**LEVY NUCLEAR PLANT, UNITS 1 AND 2
DOCKET NOS. 52-029 AND 52-030
SUPPLEMENT 2 TO RESPONSE TO REQUEST FOR ADDITIONAL INFORMATION LETTER
NO. 009 RELATED TO STABILITY OF SUBSURFACE MATERIALS AND FOUNDATIONS**

**Levy Nuclear Plant Units 1 and 2
Supplement 2 to Response to NRC Request for Additional Information Letter No. 009
Related to SRP Section 2.5.4 for the Combined License Application,
Dated February 24, 2009**

NRC RAI NUMBER: 02.05.04-7

**FIGURE RAI 02.05.04-7-1
EXAMPLE OF STATISTICAL ANALYSIS OF UNCONFINED COMPRESSIVE STRENGTH DATA
BASED ON NAV-1 AND SAV-1 LAYERS**

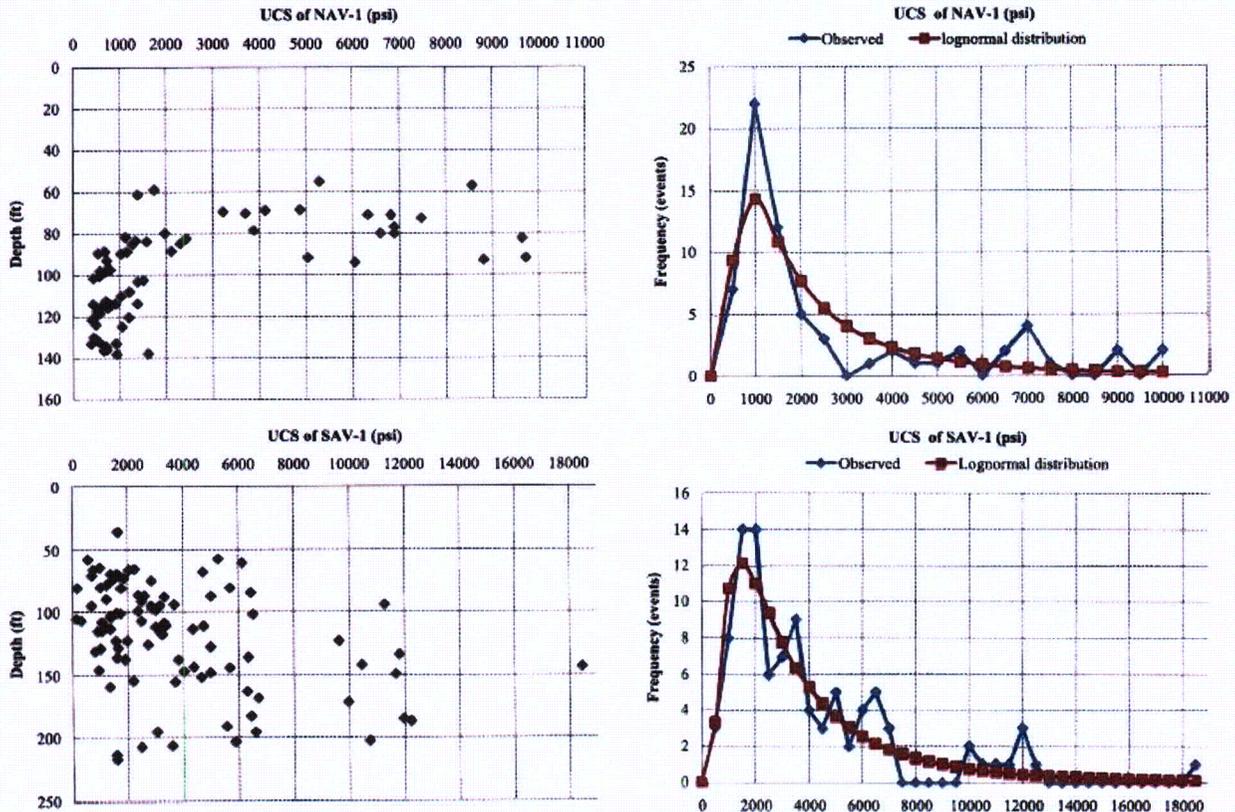
The Mohr-Coulomb strength parameters for the rock mass were based on Hoek-Brown methodology and incorporate among other factors, the intact rock compressive strength and a factor, GSI, to account for geologic features within the mass rock. FSAR Section 2.5.4 shows that great variability exists in the measured uniaxial compressive strength on intact samples (one standard deviation being as great as the average compressive strength in most cases), and the availability of intact rock samples was limited because of low recovery.

Please describe how you determined the GSI factor. Include a discussion on how the joint sets and bedding planes and low or no recovery zones were factored into the derivation of the GSI. Please describe any sensitivity analyses you may have performed to determine the influence of lower bound assumptions of the compressive strength and stiffness of intact rock and lower bound GSI factors on stability (bearing capacity and settlement) and stress calculations in the foundation rock.

A statistical analysis was performed for the Unconfined Compressive Strength to determine the variation range to be used in the sensitivity analysis. A log-normal probability distribution was determined to be appropriate for the analysis to describe the UCS. As shown below on Figure RAI 02.05.04-7-1 for the NAV-1 and SAV-1 layers, the log-normal probability distribution of the UCS data gives a better approximation of the variation range than a normal distribution of the data.
